Service Bulletin

S.B. No: 180

INSPECTION OF ALTERNATOR/STARTER WIRING LOOM P-CLIPPING AT ENGINE

FIGURE 1

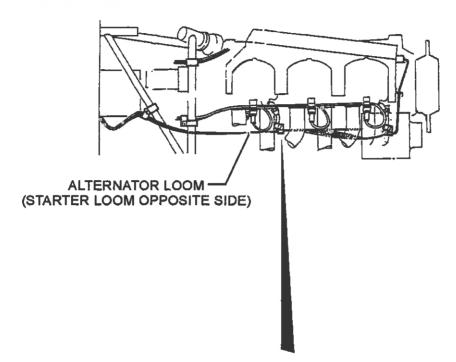
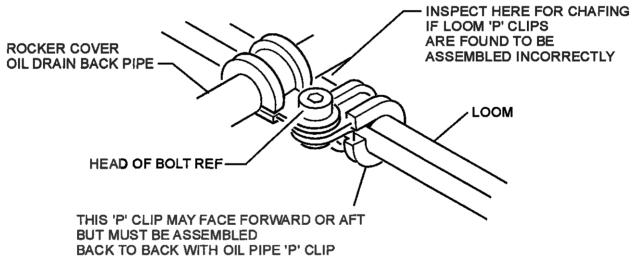
A case has been reported of the alternator wiring loom chafing against the rocker cover oil drain back pipe. On further investigation, it was found that the 'p' clip on the pipe had been fitted incorrectly, bringing the loom into contact with the pipe, which then chafed through the pipe causing oil to seep out.

- 1. Check master switch, ignition switch and fuel are OFF. Disconnect external power and hangar aircraft if required.
- 2. Gain access to the engine bay.
- 3. Inspect both the alternator wiring loom starboard side and starter loom port side of engine for correct 'p' clip assembly, ref. Figure 1. Ensure loom is positioned away from all engine components and structure.

Note: On T67A, looms may not have been clipped to the oil drain back pipe. If cables are seen to be in contact with the engine, then apply 'p' clipping as per Figure 1 detail as required.

- Should 'p' clip not be as Figure 1 then disassemble. Inspect oil drain back pipe for chaffing: if damaged replace pipe. Check looms for chafing. If looms lightly chafed, repair by re-insulating with heatshrinkable sleeving or similar permanent repair. If chafing is more severe and wire conductor is damaged, rectify by replacing affected wire.
- 5 Assemble 'p' clip and loom back to pipe as per Figure 1.
- 6. Annotate logbook "SB 180 complied with."
